MRP-227 Revision 1

Proposed Revisions to Reactor Internals Inspection and Evaluation Guidelines

October 27, 2014
Rockville, MD

Proposed Revision to Westinghouse Integrated Inspection Strategy for VS, IASCC and IE

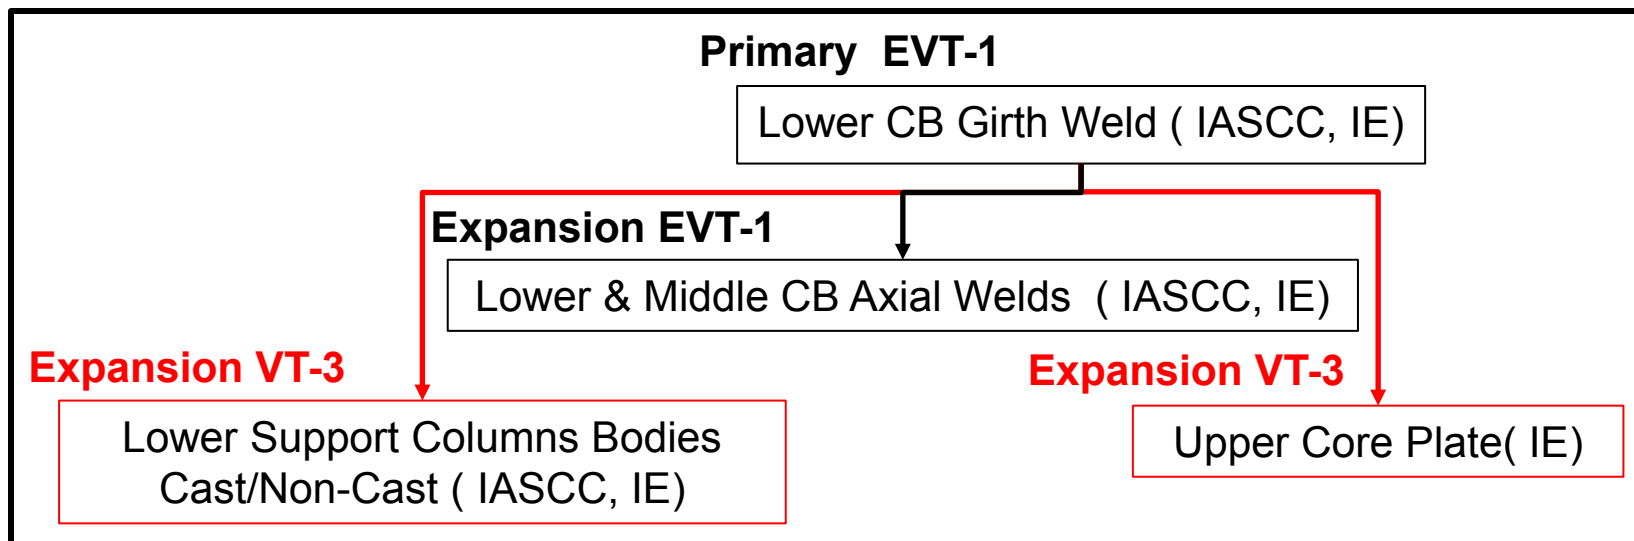
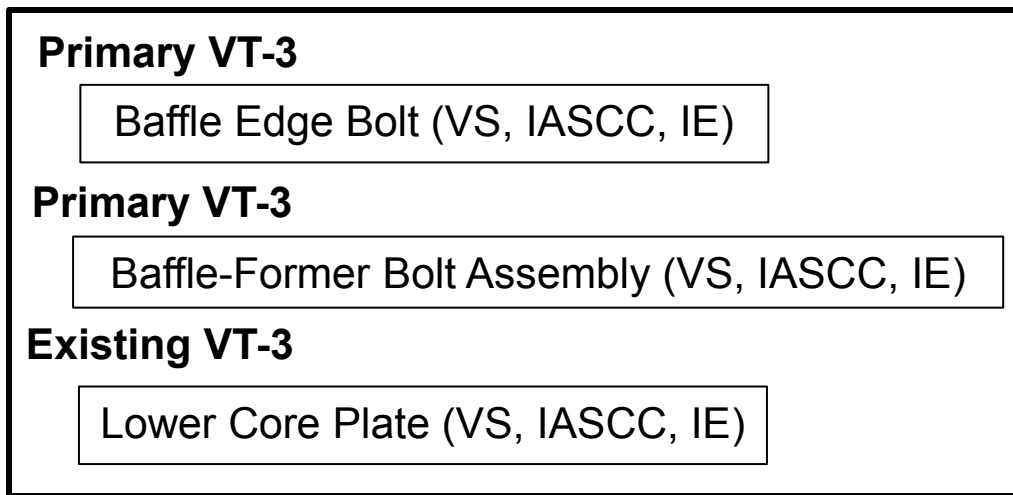
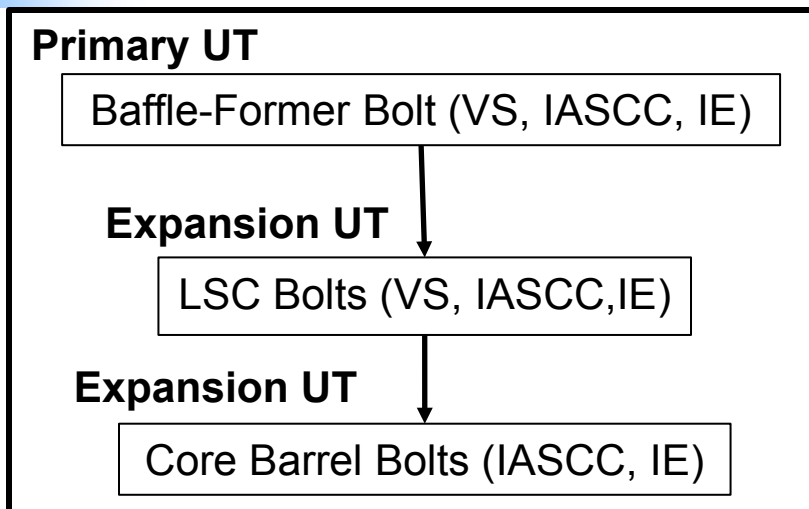
Primary UT

Baffle-Former Bolt (VS, IASCC, IE)

Expansion UT

LSC Bolts (VS, IASCC, IE)

Expansion UT

Core Barrel Bolts (IASCC, IE)

Primary VT-3

Baffle Edge Bolt (VS, IASCC, IE)

Primary VT-3

Baffle-Former Bolt Assembly (VS, IASCC, IE)

Primary EVT-1

Lower CB Girth Weld (IASCC, IE)

Expansion EVT-1

Lower & Middle CB Axial Welds
(IASCC, IE)

Red: Proposed MRP-227 Rev. 1

Black: MRP-227-A Rev. 0

Figure 2 - Example of Wear at the Radial Key/Clevis Insert Interfacing Surface

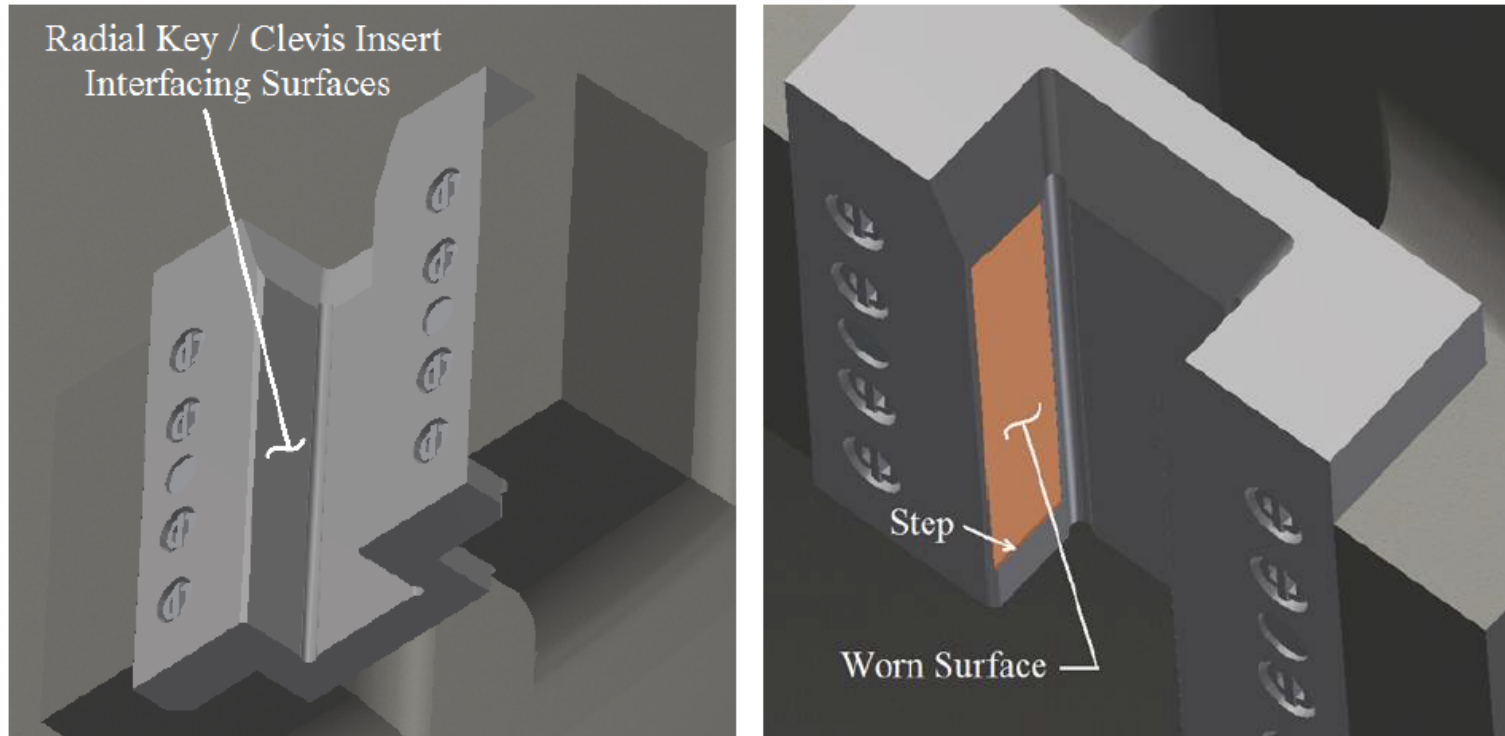
- Ensure that clevis insert inspections performed during 10-year ISI exams include following scope:
 - Radial key/clevis insert interfacing surfaces; look for aggressive or abnormal wear as compared to previous inspection, if available. The radial key does not make contact with the full length of the clevis insert; if wear is significant it would be visible as a step located toward the bottom end of the clevis insert as shown in Figure 2.
 - Interface between the clevis insert and vessel lug (see Figure 3); look for signs of looseness or dislocation. Faces of the insert and vessel lug are generally flush; dislocations may be visible by the insert protruding toward the vessel centerline as compared to the vessel lug.

- PWROG Clevis Insert Program
 - Document technical basis supporting safe operation with failed clevis insert bolts for all W & CE NSSS.
 - Develop an RAI response template
 - Advise of potential commercial implications of failed bolts
- MRP-227 Revision 1
 - Add to existing note to reference Westinghouse TB-14-5

Figure 4 - Examples of Bolt and Dowel Pin Related Degradation

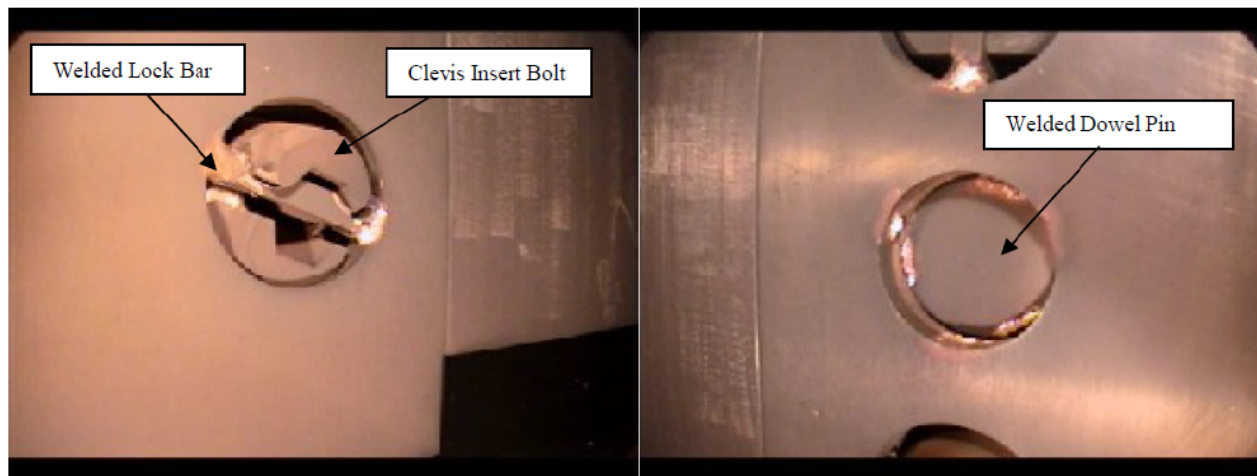
- Look for wear between the bolt head and lock bar and/or bolt head dislocation.
- Look for broken tack welds and dislocation of the dowel pin.
